1R - 425-66

RE: Initial CAP Report – Liner Installation
NMOCD Case #: 1R425-66
Vacuum L-26 Vent Site, T17S, R35E, Section 26 (L)

From: Katie Jones
Sent: Friday, April 01, 2011 3:07 PM
To: Hansen, Edward J., EMNRD
Cc: Hack Conder; 'Katie Lee'
Subject: Vacuum L-26 vent (1R425-66) CAP Addendum

Vacuum L-26 vent

Proposed liner

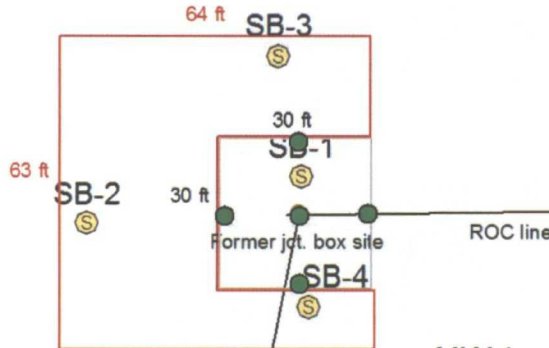
This email is an Addendum to the Vacuum L-26 vent site (1R425-66) Initial Characterization Report and Corrective Action Plan (CAP), submitted to the NMOCD on September 14, 2010. Page 3, section: Recommendations, paragraphs 1-3: text in blue lettering, below, will replace text in red lettering, below. A new plat showing the proposed liner dimensions and the previously submitted Initial Characterization Report and CAP are attached. If you need any further information, please let me or Hack know.

To further protect groundwater from potential chloride migration, ROC proposes to excavate soil with a 64x63-ft area to a depth of approximately 5 to 4-ft below ground surface (bgs) and properly seat a 20 mil, reinforced polyethylene liner in the base of the excavation. Backfill soils will not exceed a chloride concentration of 500 mg/kg and a PID (field) ready of 100 ppm. Excavated soil will be evaluated for use as backfill and any soil requiring disposal will be properly disposed of at a NMOCD approved facility. The site will then be seeded with native seed mixes and soil amendments will be added as necessary to encourage re-vegetation. As plants capture water through their roots, they reduce the volume of water infiltrating below the root zone and create a natural "infiltration barrier" that will remain in place after the buried synthetic liner degrades. Both the synthetic liner and vegetation help protect ground water as the decreased flux of water through the subsurface slows the transportation rate of residual chloride in the subsurface, allowing dilution and dispersion to decrease possible adverse impact to ground water.
